M72/M78 "HOP" AUDIO

M72 EVT

CHANGE LIST (CHANGES FROM M51)

APPLE COMPUTER INC.	SIZE	DRAWING NUMBER	REV.
	D	051-7246	0.0.1
SCALE	SHT	OF	
NONE	1	109

AUDIO: SPEAKER AMP_1

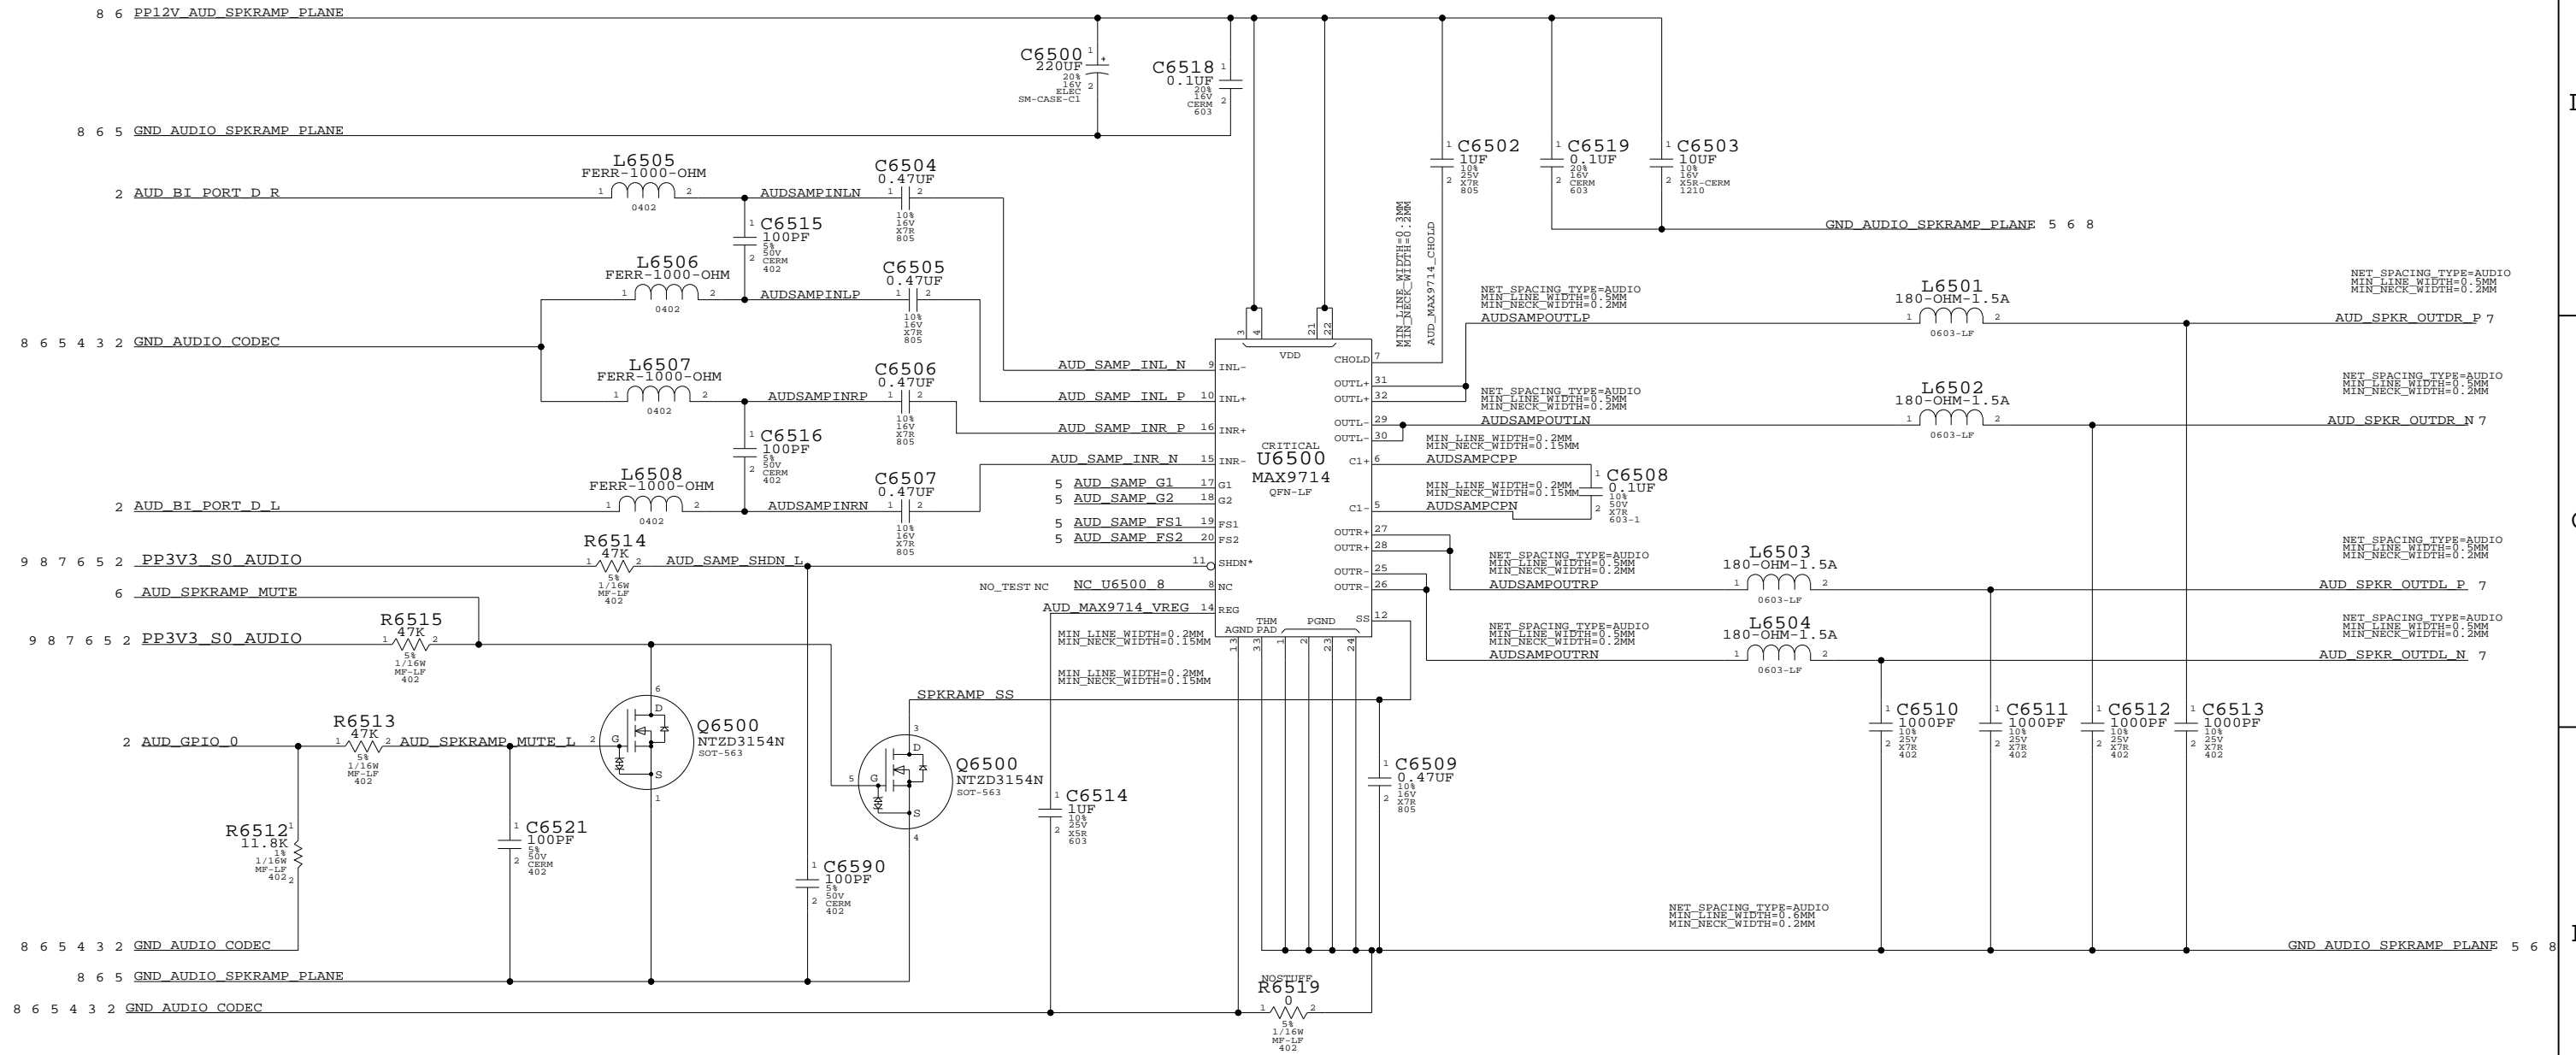
22. CHANGED R6308 TO 28K ON PAGE 63
 23. CHANGED R6410 TO 10 OHMS. CHANGED NOTES FROM LINE OUTPUT TO HEADPHONES ON PAGE 64
 24. CHANGED L6506, L6507, L6508, L6605, L6606, L6607, L6608 TO 0402 PACKAGES PAGES 65 AND 66

62. CHANGED PULL DOWN RESISTORS ON OUTPUT OF MAX922 TO 2.4K FROM 1K TO AID IN THD+N
- 29JAN07
 63. CHANGED O6500 TO MATCH O6800-O6802 (BOM COMSOLIDATION)

AUDIO: CONNECTORS

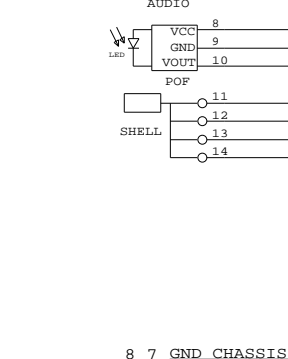
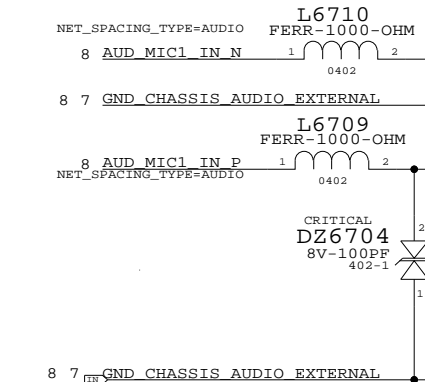
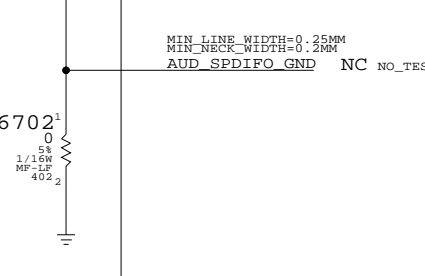
25. CHANGED ALL CHASSIS NET NAMES TO THE SAME (GND CHASSIS AUDIO EXTERNAL) PAGE 67
 26. CHANGED NET NAME ON J6702 PINS 3 TO NC. ADDED CHASSIS GND'S TO PINS 3 & J6701, PINS 6, 7, J6702

27. NOSTUFFED DZ6702 AND DZ6705 AS THEY SHOULD NEVER BE NEEDED DUE TO LOCATION OF PIN DEEP INSIDE CONNECTOR
 28. CHANGED REFERENCES TO LINE OUTPUT ON PAGE 68 TO BE REFERENCES TO HEADPHONES
